TENDER NUMBER TEN16699

ROCKHAMPTON SPORTS PRECINCT – STAGE 1 NETBALL

ADDENDUM NO. 7

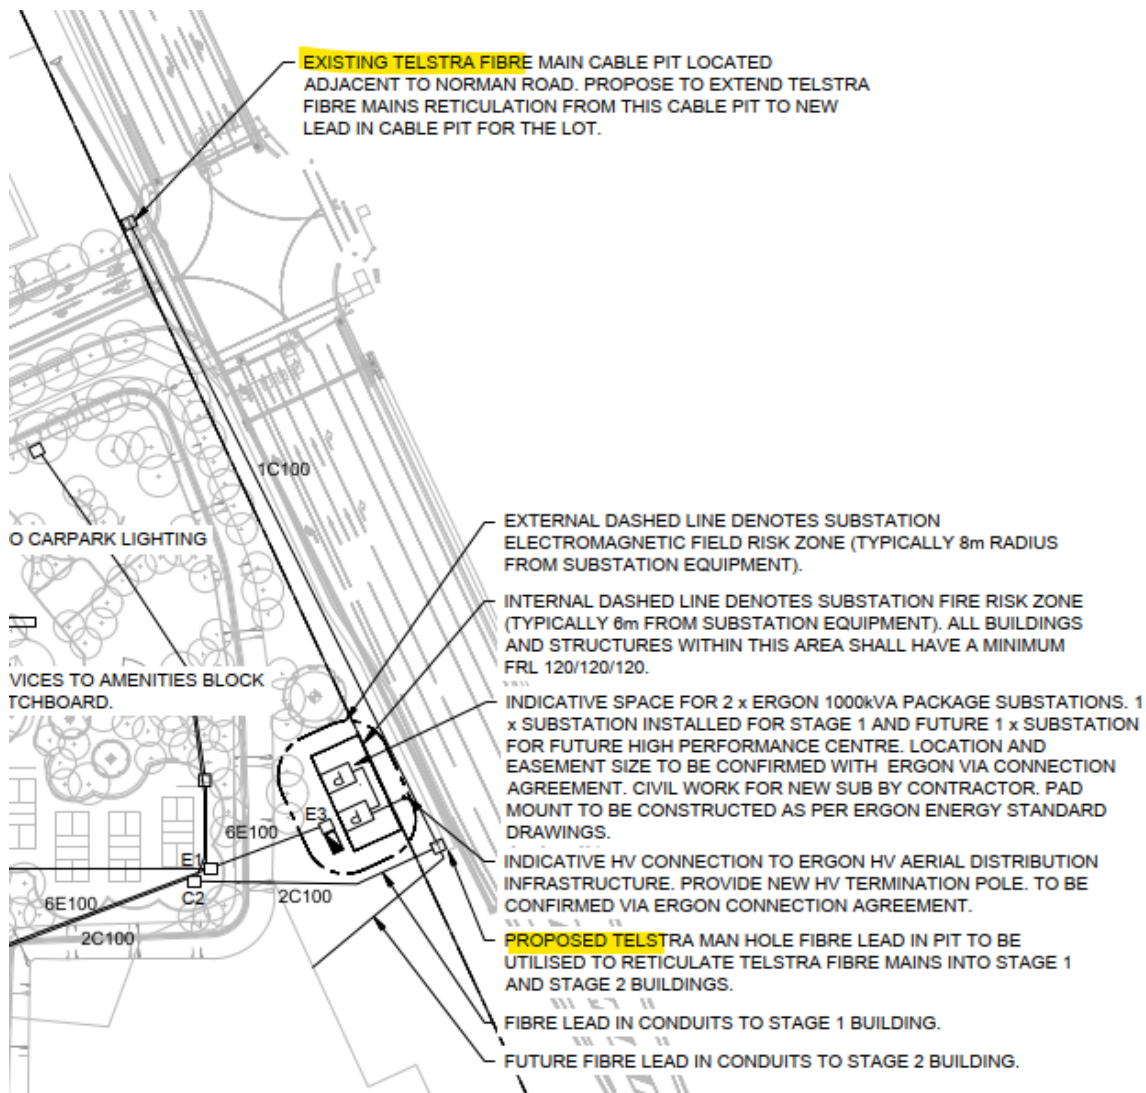
8. AV Integration - What is the existing AV system and where is it located?

There is no existing AV system, refer to Electrical Services Specification 28. AV System for details.
